House to Pool House Water line
B17002900

Information Form for the Installation of the Well Pump, Pitless Adapter, and Supply Piping

Name of Property Owner: Scott Newman Telephone #: 301 787 4989
Subdivision: Chelsea Knolls Drive Lot #: 10 Well Tag #: HO-15-0329
Site Address: 18380 Chelsea Knolls Drive
Mount Airy, MD 21771 In Reference to B17002900

From: Greg Kennell <gregk@browningpools.com>
Sent: Friday, June 08, 2018 11:33 AM
To: Cabahug, Joseph
Subject: Re: 18380 Chelsea Knolls Drive _ Inspection Debrief

1 SITE PLAN
1/16" = 1'-0"

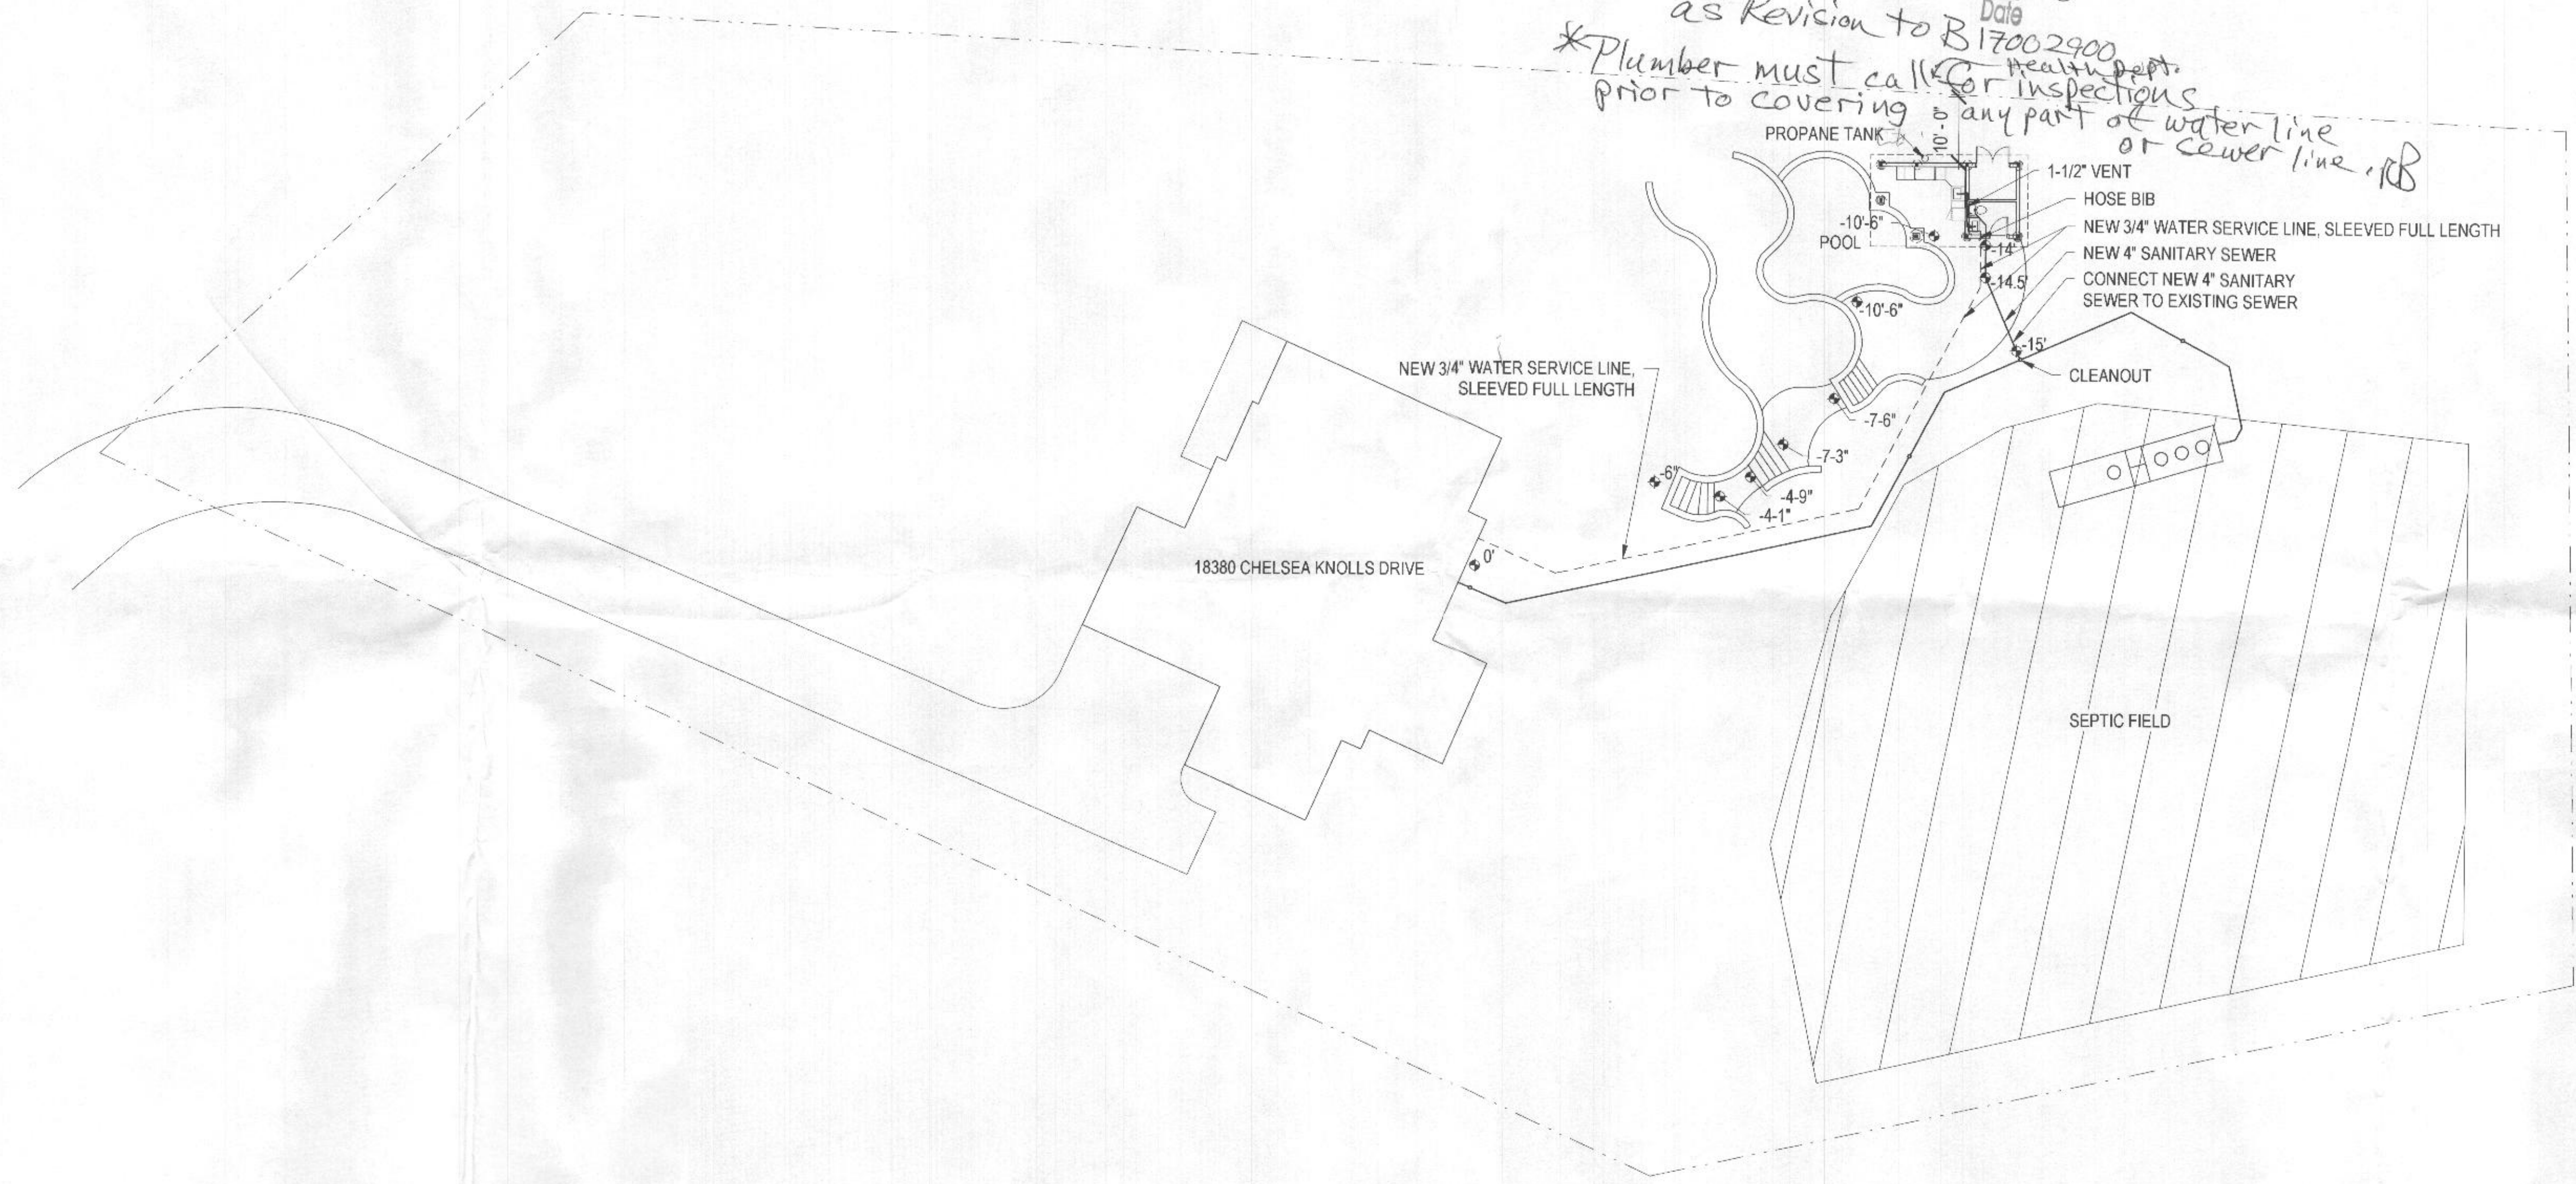
6/7/2018 (Signature)
water line installed from house to pool house. SEE Attachment for well line depth.

Please send a statement confirming that the water line will be covered with at least 36" of fill to meet the frost line requirement.

In accordance with Howard County Code the sewer line will need to be replaced with 4" piping. Please call for reinspection;

All piping from the building drain to the distribution box shall be four inches or larger SDR-35 PVC, or SCH 40 DWV PVC pipe, or approved equal.

Per our conversation on 6/7/18 regarding the water line depth at 18380 Chelsea knolls drive, Browning Pools will ensure that the water line be covered with at least 36 inches of soil to be below frost line at finished grade. Agreement has been sent that the 3" line is approved for the system and does not need to be replaced. If any further questions need to be addressed please let me know.

I got word from my supervisor. The 3" is ok and will not need to be replaced and reinspected.

We will still need a statement that the waterline will be covered with at least 36" of fill in order to meet the frost line requirement at the time of final grading.
